5201 RAINIER AVE S SDCI # 30183789

2 | 5201 RAINIER LLC | S+HWorks | 5201 Rainier Ave S EARLY DESIGN GUIDANCE SDCI # 3018378

EDG 2 BOARD RECOMMENDATIONS

EDG 3 CONCEPT C: PLANS

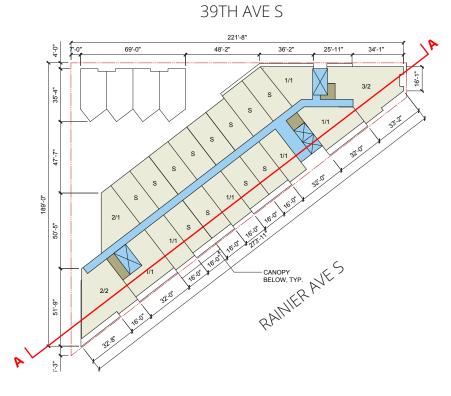
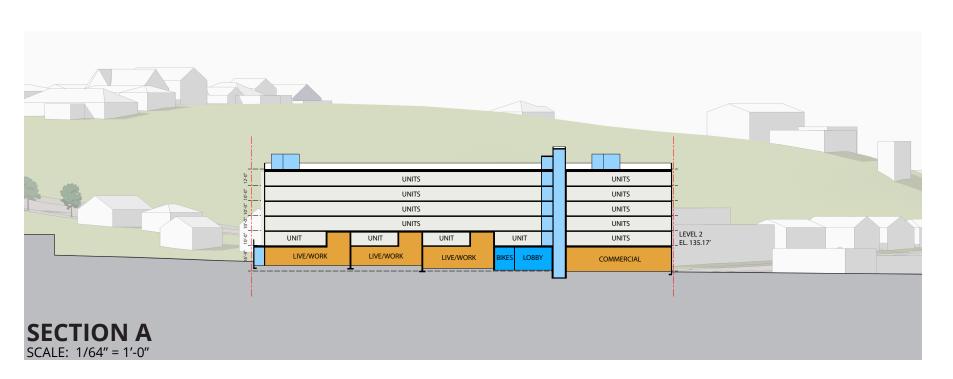
MASSING/TRANSITION: NORTH CORNER (CS2.C.1, CS2.D)

- PROJECT TRANSITIONS BETWEEN COLUMBIA CITY AND HILLMAN CITY.
- EXPLORE STRATEGIES TO MITIGATE HEIGHT, BULK AND SCALE.
- · CONSIDER OPEN SPACE/PUBLIC AMENITIES TO SOFTEN THE CORNER.

1B MASSING/TRANSITION: SOUTHEAST CORNER (CS2.D)

- PROJECT TRANSITIONS BETWEEN COLUMBIA CITY AND HILLMAN CITY.
- EXPLORE STRATEGIES TO MITIGATE HEIGHT, BULK AND SCALE, AND ENHANCE VISIBLE CORNER.

MASSING/CONCEPT (CS2.D)

- · BOARD SUPPORTED CONCEPT C, INCLUDING THE TOWNHOUSES TO TRANSITION TO LR2.
- CONSIDER METHODS TO ENHANCE THE TRANSITION BETWEEN THE MASSES.

GARAGE ENTRANCE (DC1.B.1)• EXPLORE ARCHITECTURAL IMPLICATIONS FOR MOVING GARAGE ENTRANCE SOUTH.

• EXPLORE PLAZA DESIGN FOR ACCESS AND USABILITY WITH RELATIONSHIP TO RESIDENTIAL EDGES.

- BUILDING FOOTPRINT AND BULK REDUCED AT THE CORNER. (CS2.A.1)
- SMALLER SCALE ARTICULATION EXTENDED AROUND NORTH CORNER. (DC2.A.2, DC2.B.1)
- · CORNER ELEMENT ENHANCED FOR FOCAL POINT. (CS2.C.1)
- MORE AREA AVAILABLE FOR CORNER AMENITY AT GRADE. (PL3.C.3, DC3.C.2)

- MOVED STAIR TOWER INTO INTERIOR TO REDUCE BULK. (CS2.D.1, CS2.D.3)
- SHIFTED ARTICULATION SOUTH; LOWER MASSING NEAR 40' NEIGHBOR. (DC1.A.2)
- REDUCED BUILDING FOOTPRINT; MORE SEPARATION AND FENESTRATION. (CS2.D.5)

- MATERIALS AND FENESTRATION PALETTE WILL UNIFY MASSING. (DC2.B.1)
- PRIVACY STUDY WILL MITIGATE RELATIONSHIP BETWEEN UNITS.

EXPLORED ALTERNATE GARAGE LOCATIONS - PREFERRED SCHEME IS MOST ARCHITECTURALLY CONSISTENT. (DC1.B.1)

- DECENTRALIZED LANDSCAPING IN PLAZA TO ALLOW FOR MORE SMALL SPACES. (DC3.B.1)
- CREATED COVERED LOGGIA FOR SEVERAL UNITS FACING PLAZA. (DC3.B.4)
- ADDED INTERIOR LOUNGE AND SECOND INTERIOR ACCESS POINT FOR ENHANCED CIRCULATION. (DC3.A.1)

EDG 2 CONCEPT C: NORTH CORNER

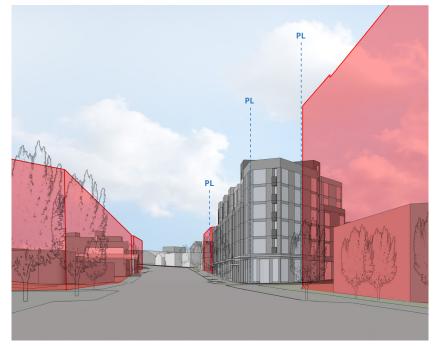
- MASSING/TRANSITION: NORTH CORNER (CS2.C.1, CS2.D)

PROJECT TRANSITIONS BETWEEN COLUMBIA CITY AND HILLMAN
 - EXPLORE STRATEGIES TO MITIGATE HEIGHT, BULK AND SCALE.
 - CONSIDER OPEN SPACE/PUBLIC AMENITIES TO SOFTEN THE CORNER.

• STRONG 'PROW' ON RAINIER CREATES VISIBLE FOCAL POINT.

- · CORNER MASSING TOO DOMINANT AND INCONSISTENT WITH ARTICULATION CONCEPT.
- · LARGE FOOTPRINT AT CORNER LIMITS ON-GRADE AMENITY.

EDG 3 CONCEPT C: SOUTHEAST CORNER

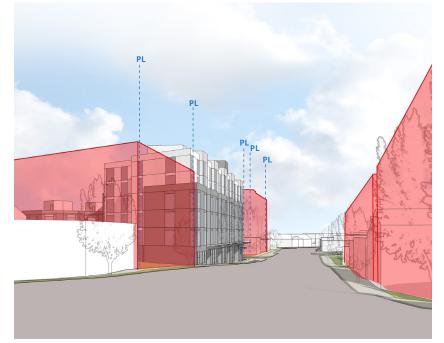
- MASSING/TRANSITION: SOUTHEAST CORNER (CS2.D)

PROJECT TRANSITIONS BETWEEN COLUMBIA CITY AND HILLMAN
 - ullet EXPLORE STRATEGIES TO MITIGATE HEIGHT, BULK AND SCALE AND ENHANCE VISIBLE CORNER.

- BULKY PENTHOUSE MASS AT SOUTH PROPERTY LINE.
- MINIMAL SETBACK FOR WINDOWS AT PROPERTY LINE.

1B MASSING/TRANSITION: SOUTHEAST CORNER MODIFICATIONS:

- STAIR TOWER & PENTHOUSE MOVED AWAY FROM CORNER, REDUCING BULK OF THE BUILDING MASS.
- INCREASED SETBACK AT PROPERTY LINE CREATES MORE SEPARATION BETWEEN BUILDINGS.
- · MASSING ARTICULATION SHIFTED TO CORNER TO EMPHASIZE AND TERMINATE FACADE RHYTHM.

- CLEAR EXPRESSION OF ARTICULATION CONCEPT AS IT TERMINATES AT THE BUILDING CORNER. (DC1.B.1)
- LOWER MASSING ARTICULATION CREATES STRONG DATUM RELATIONSHIP TO SOUTH NEIGHBOR. (CS2.D.1, CS2.D.3)
- CONSISTENT SIGHT LINE IS ESTABLISHED ALONG RAINIER. (CS2.A.2)
- GLAZING ADDED AT CORNER TO LIGHTEN THE MASS AND CREATE FURTHER VISUAL INTEREST. (CS2.D.5)
- EXIT COURT WILL INCLUDE PAVING, SECURITY GATE AND LANDSCAPING. (CS2.D.5)

EDG 3 CONCEPT C: MASSING TRANSITION **1**

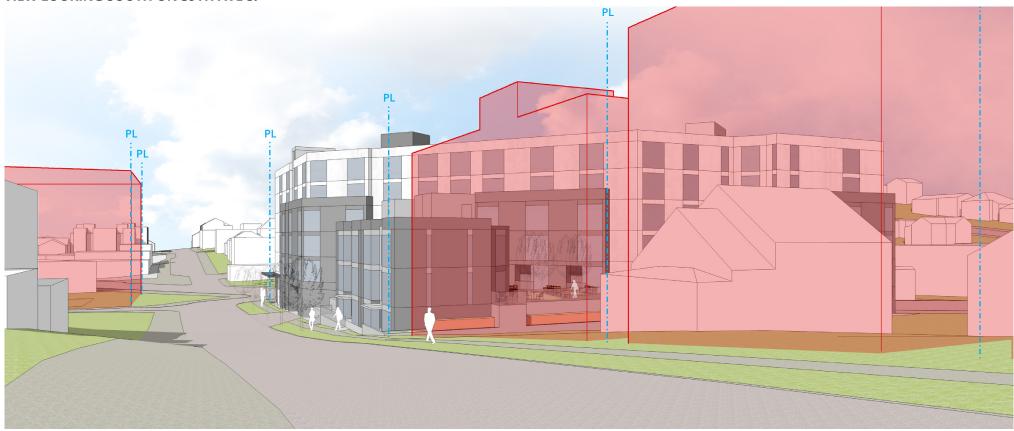
MASSING/CONCEPT (CS2.D)

- BOARD SUPPORTED CONCEPT C, INCLUDING THE TOWNHOUSES TO TRANSITION TO LR2.
- CONSIDER METHODS TO ENHANCE THE TRANSITION BETWEEN THE MASSES.

- MATERIAL AND FENESTRATION PALETTE CREATE VISUAL CONNECTION BETWEEN MASSES. (DC2.B.1)
- LANDSCAPED TERRACES BRIDGE BETWEEN THE TWO ELEMENTS, CLEARLY DISTINGUISHING BETWEEN THE TWO MASSES. (PL3.B.1, DC2.B.2)
- TERRACES PROVIDE LIMITED VIEW INTO PLAZA, ALLUDING TO OPEN SPACE CONNECTION BETWEEN ELEMENTS. (PL3.C.2, DC2.D.2)
- TOWNHOUSE FLOOR PLANS MAXIMIZE OPPORTUNITY FOR PRIVACY BETWEEN BUILDINGS. (DC2.C.3)
- TOWNHOUSE ENTRIES ARE CLEARLY DEFINED BY LOW WALLS AND PLANTINGS. (PL3.B.2)

- HIGHER TOPOGRAPHY GIVES MORE CLEAR VIEW OF OVERALL MASSING. (CS2.D.2)
- REPETITION OF MATERIAL AND FENESTRATION PALETTE EMPHASIZES RELATIONSHIP BETWEEN ELEMENTS. (DC2.B.1)
- VIEW INTO PLAZA EXPRESSES THE OPEN SPACE AMENITY BETWEEN THE TWO ELEMENTS. (PL3.C.2)
- TOWNHOUSE FLOOR PLANS MAXIMIZE OPPORTUNITY FOR DAYLIGHTING AT PLAZA. (DC2.A.1)
- TERRACED LANDSCAPING AT SOUTH BREAKS DOWN BLANK WALLS. (CS2.D.5, DC2.B.2, DC2.D.2)
